KANSAS CITY AREA TRANSPORTATION AUTHORITY

Invitation for Bids (IFB) #F23-5003-39A
Traction Power Substation – KC Streetcar Riverfront Extensions (Package 3)

ADDENDUM #2

Issue Date: February 7, 2023

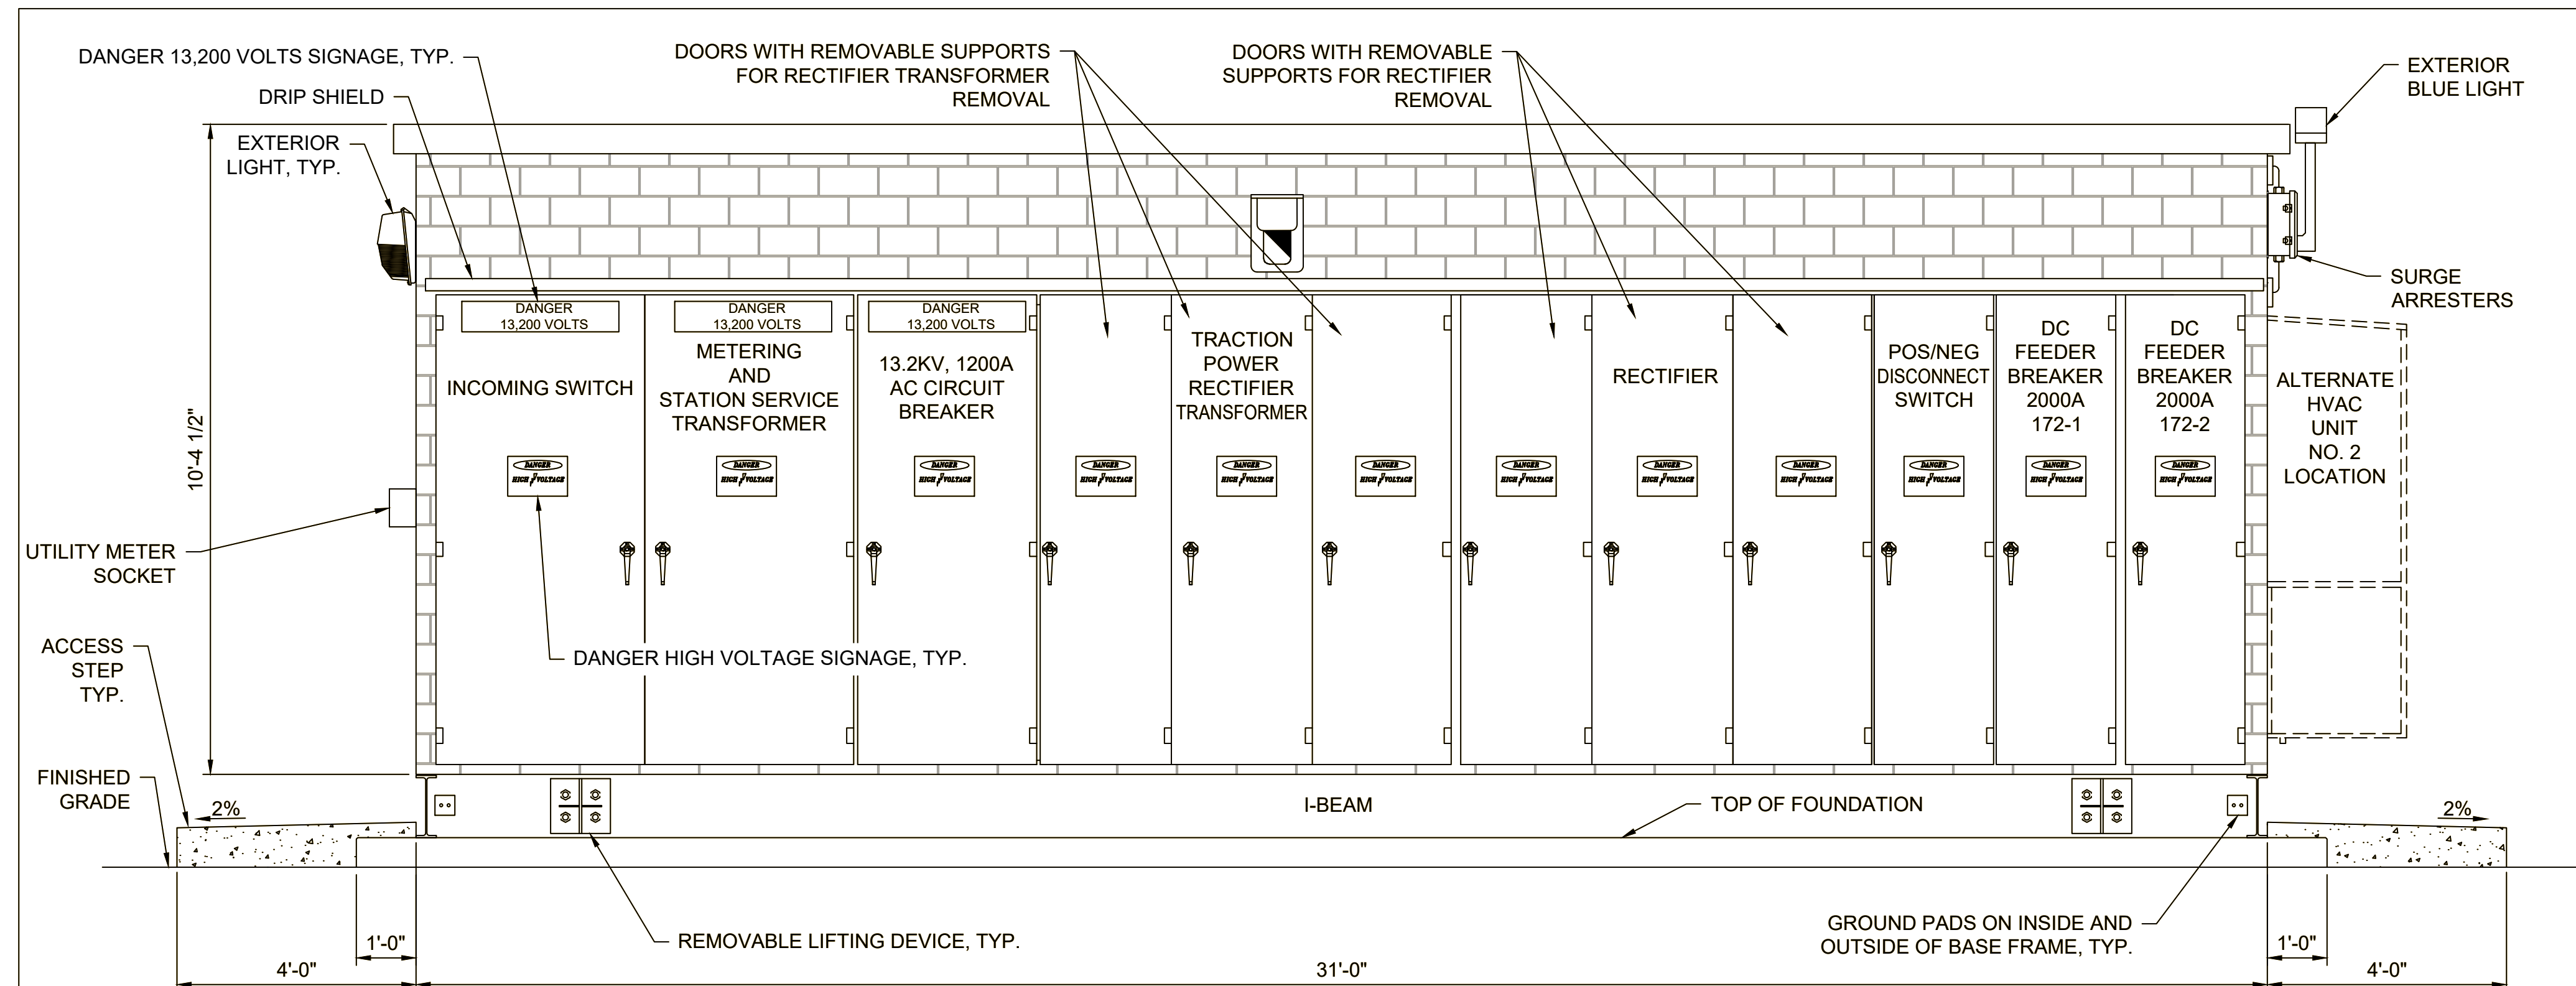
Red text and lines are the older version. Green text and lines are the updates. See updated BATES 304477 - 304504 for clean updated plan sheets.

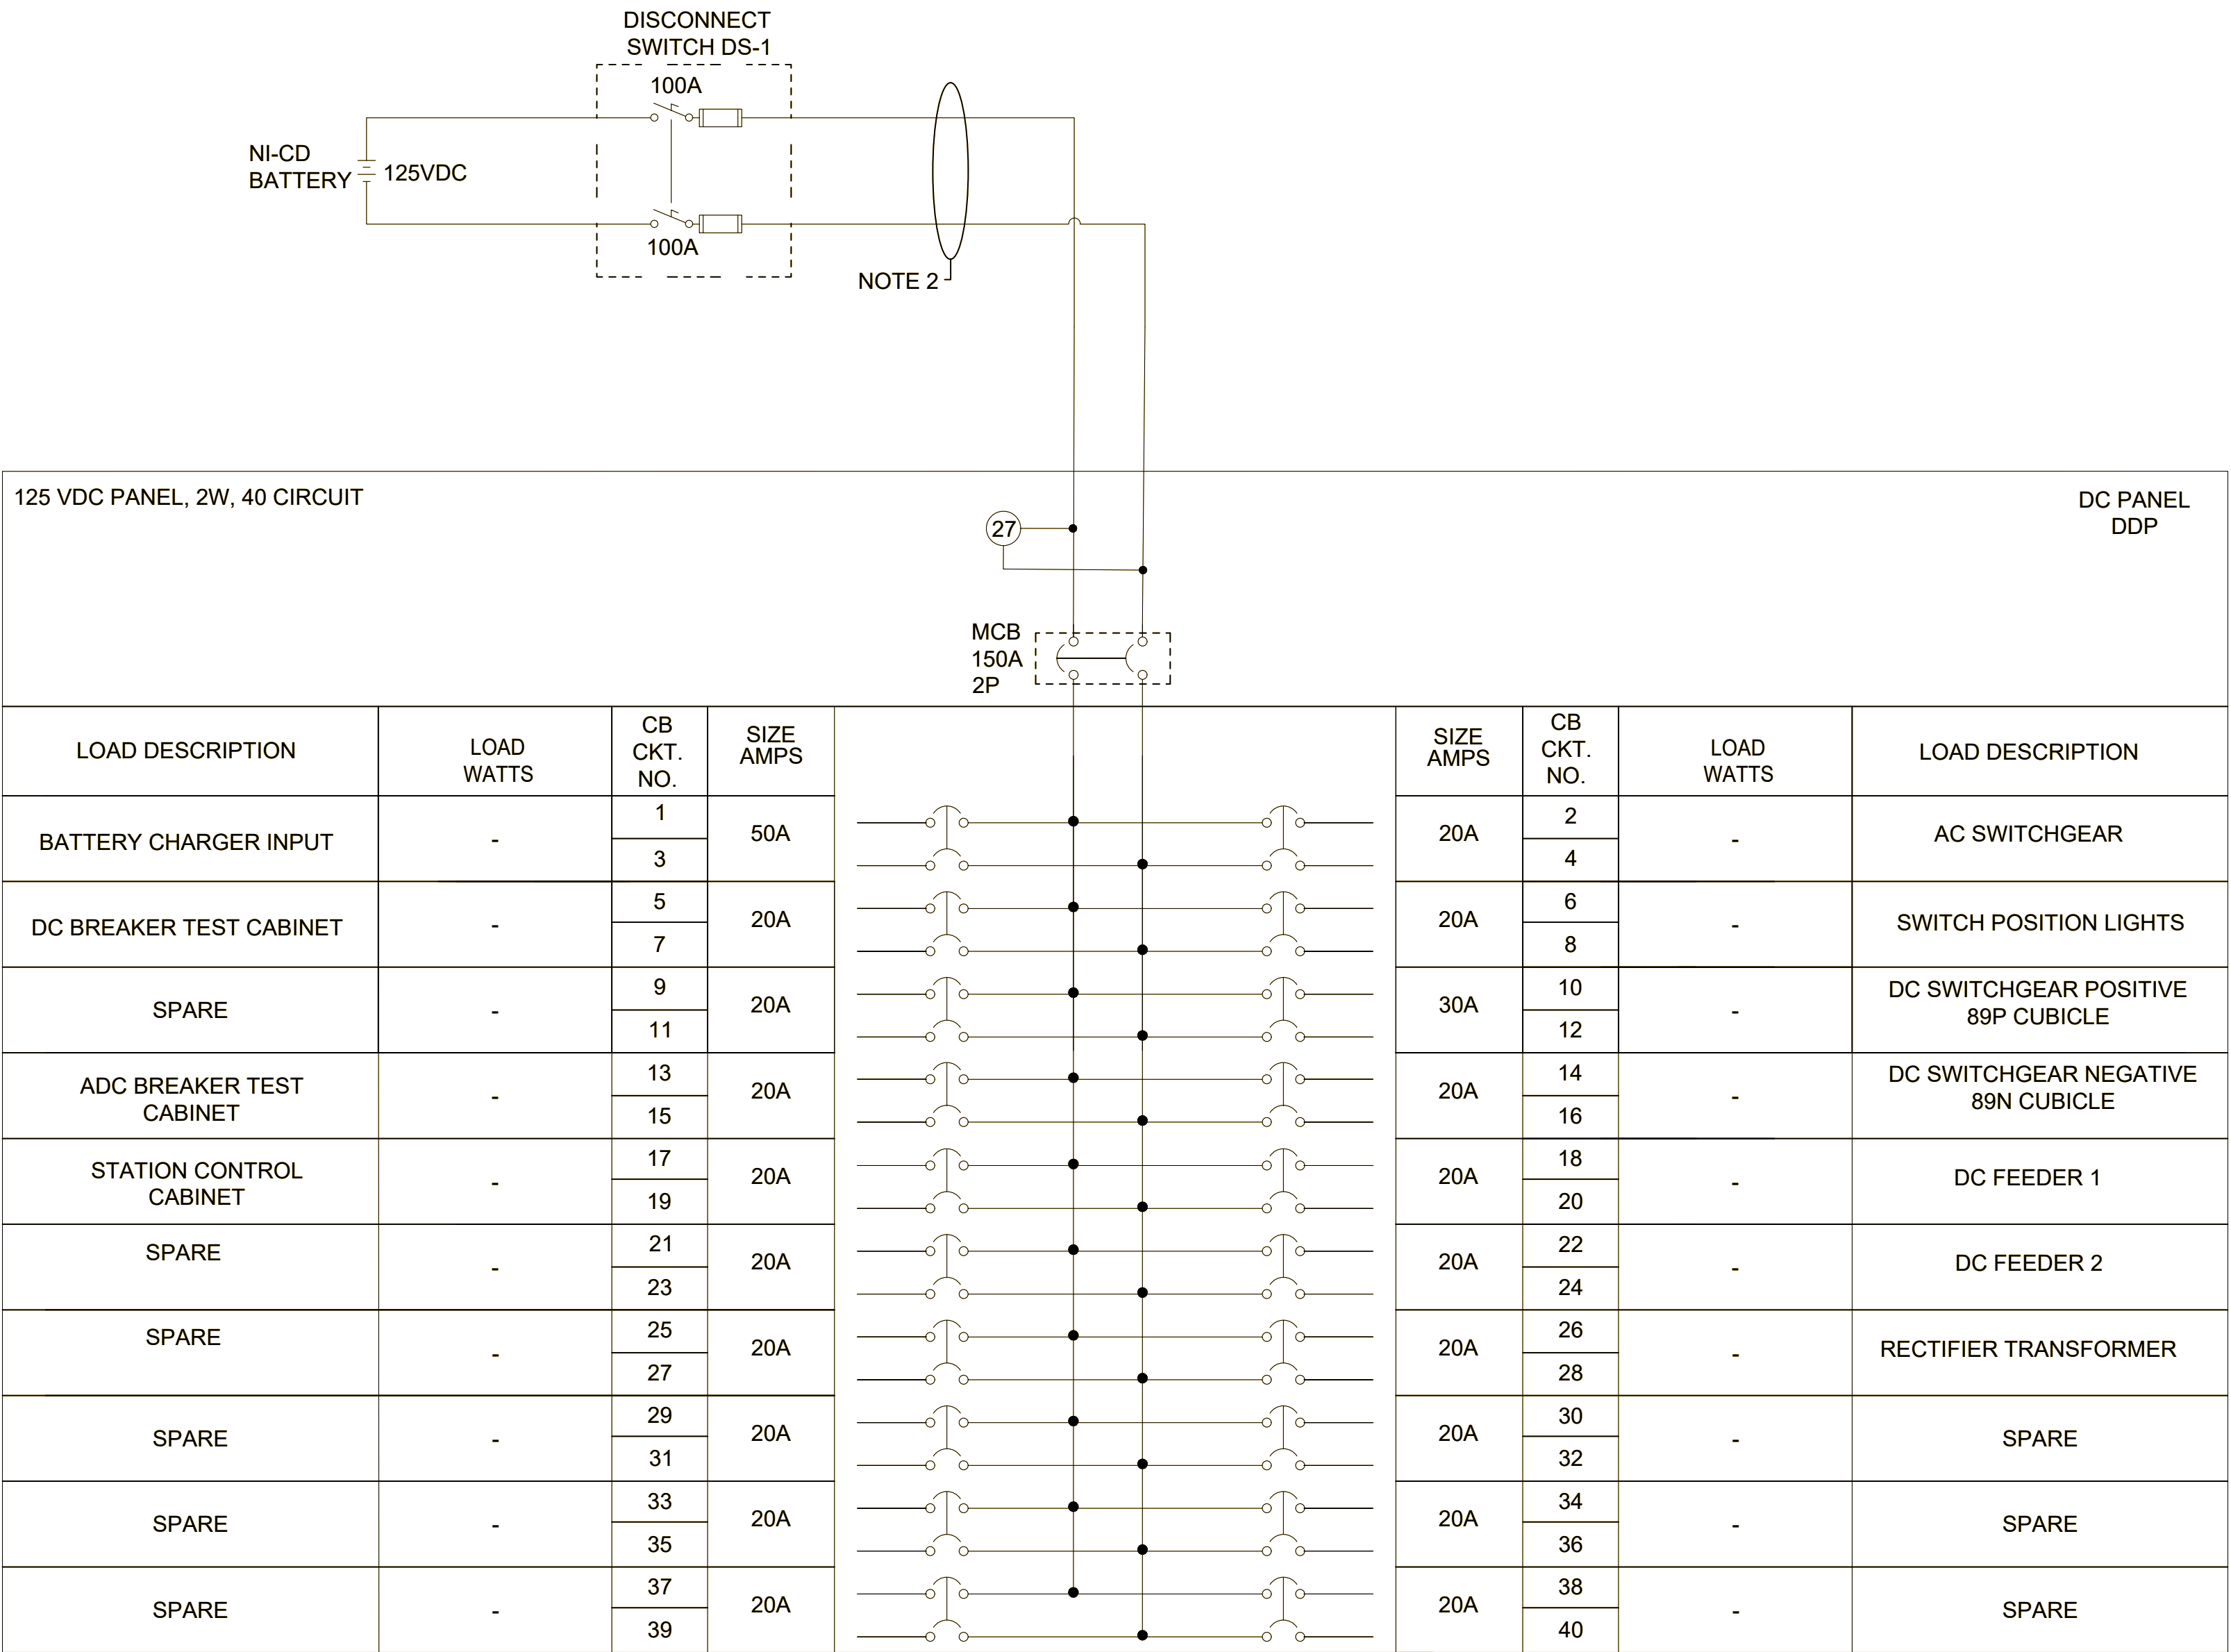
Red text and lines are the older version. Green text and lines are the updates. See updated BATES 304477 - 304504 for clean updated plan sheets.

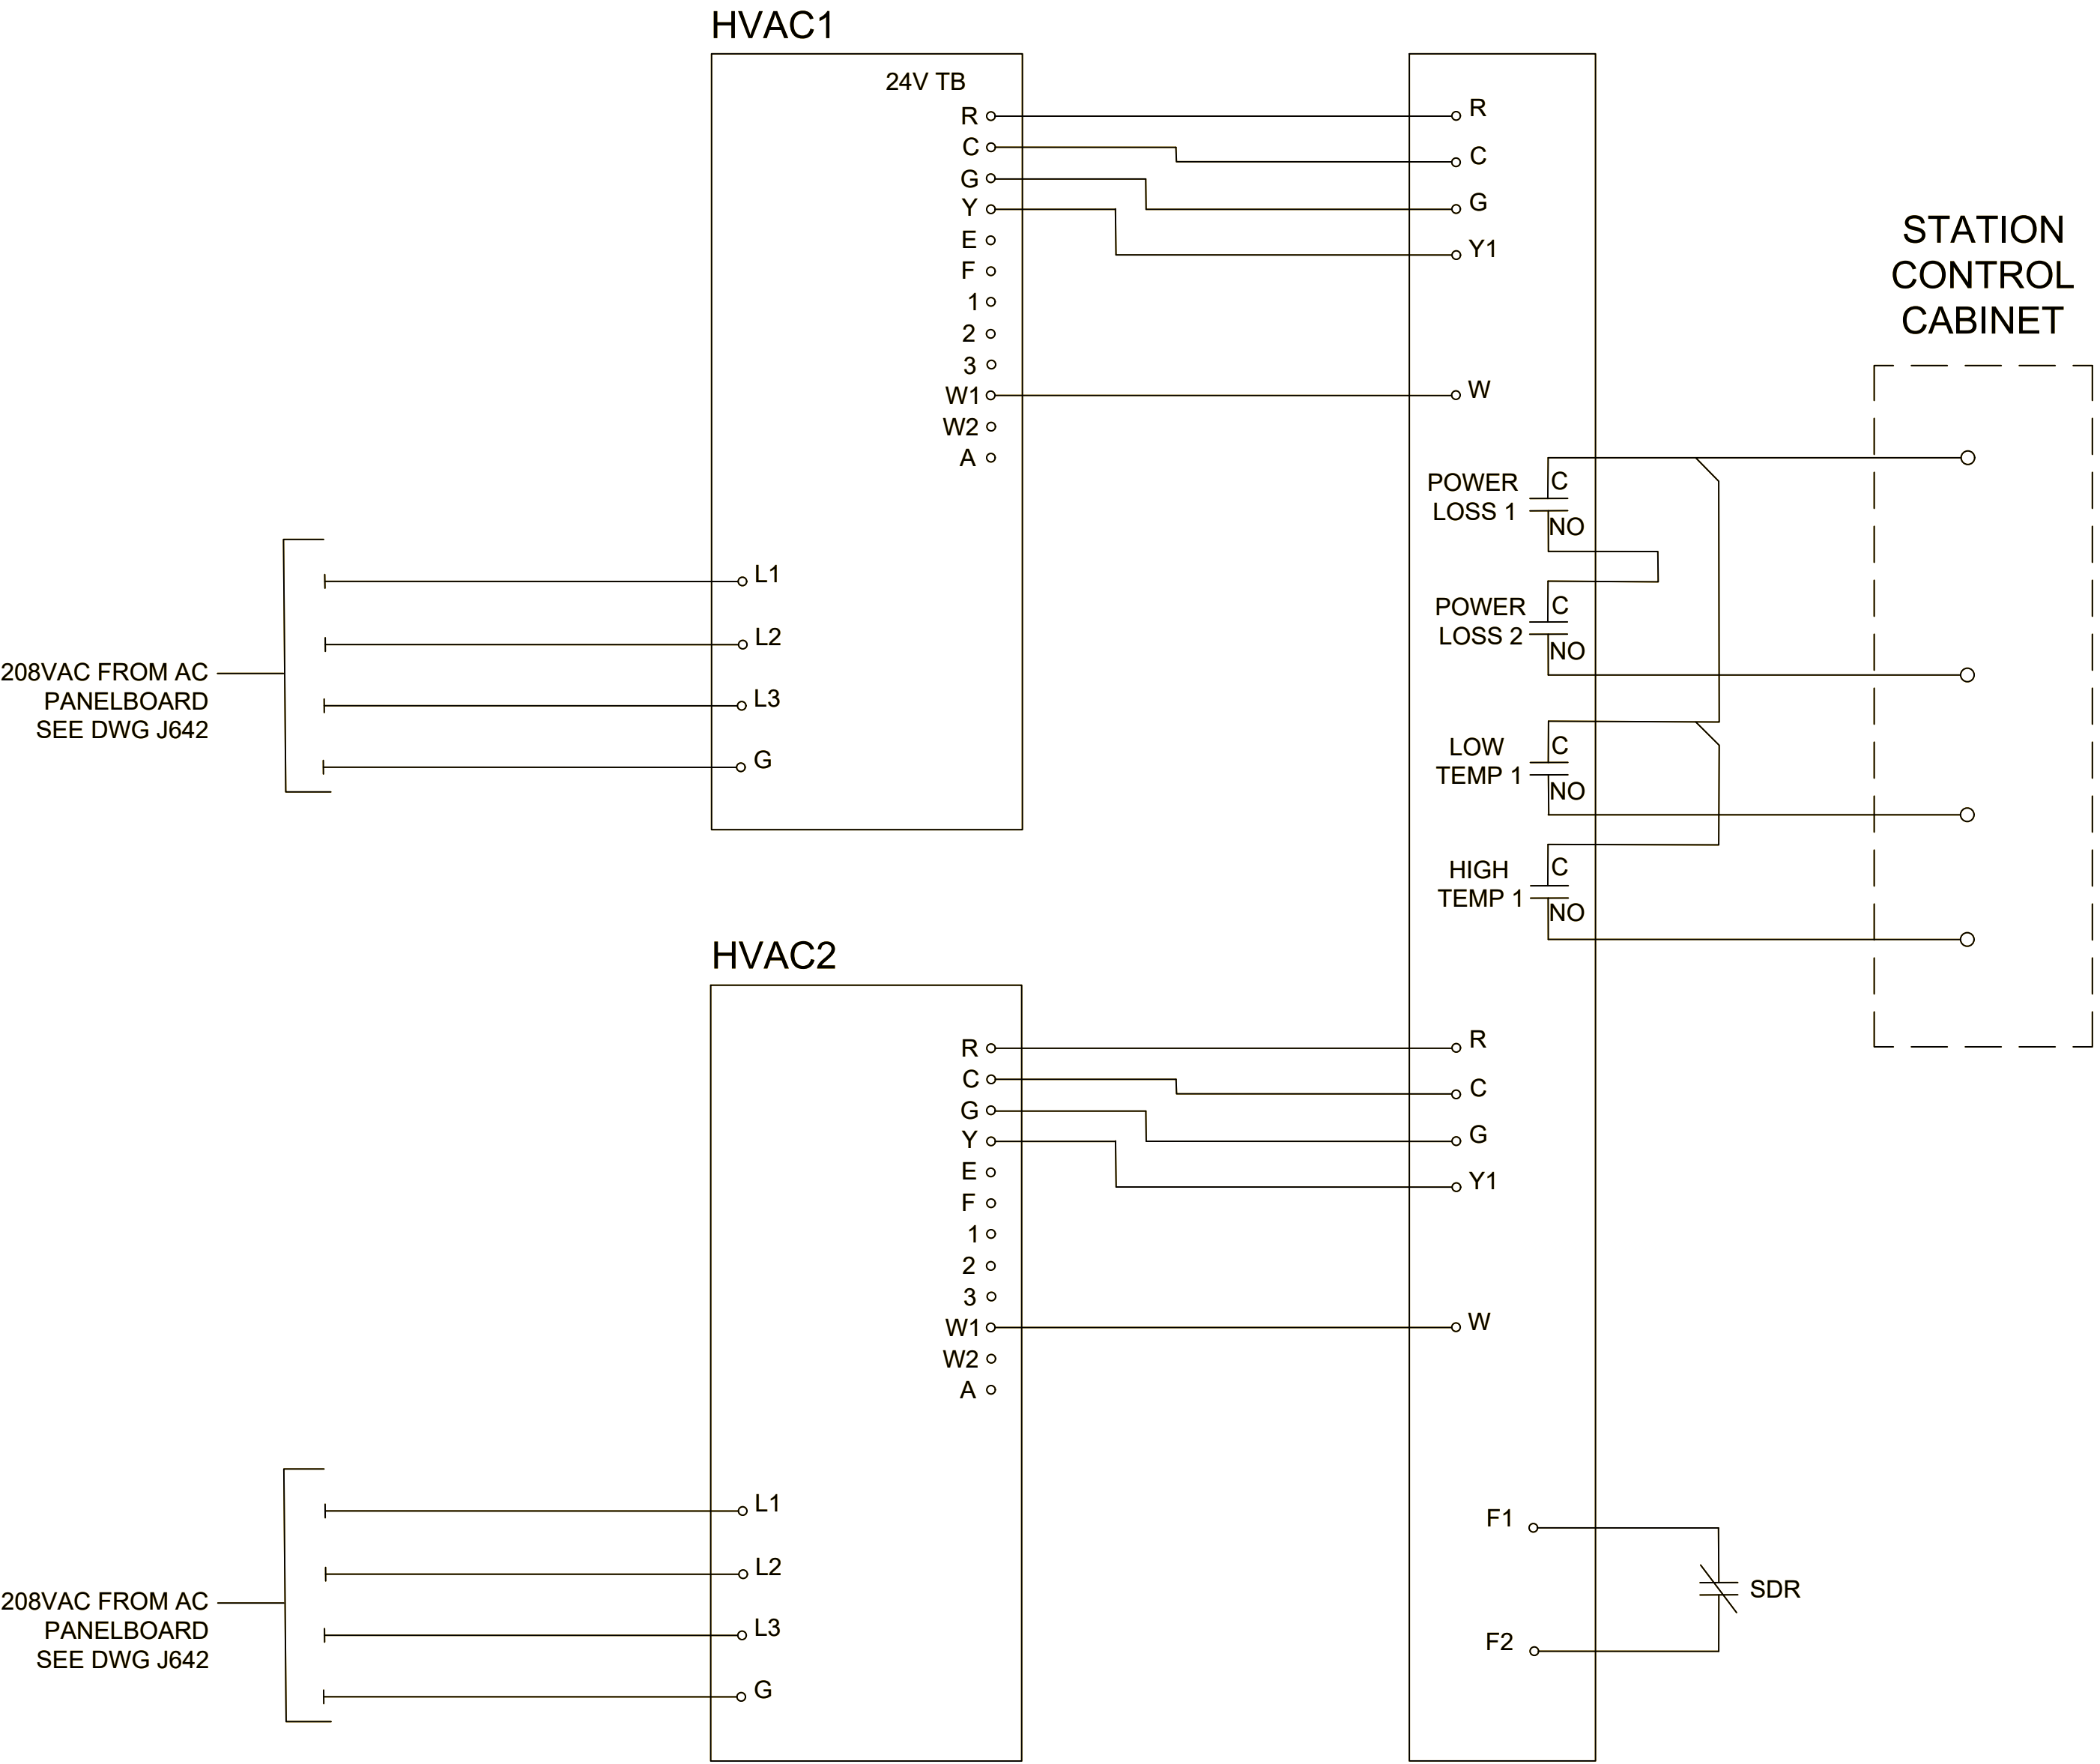
Red text and lines are the older version. Green text and lines are the updates. See updated BATES 304477 - 304504 for clean updated plan sheets.
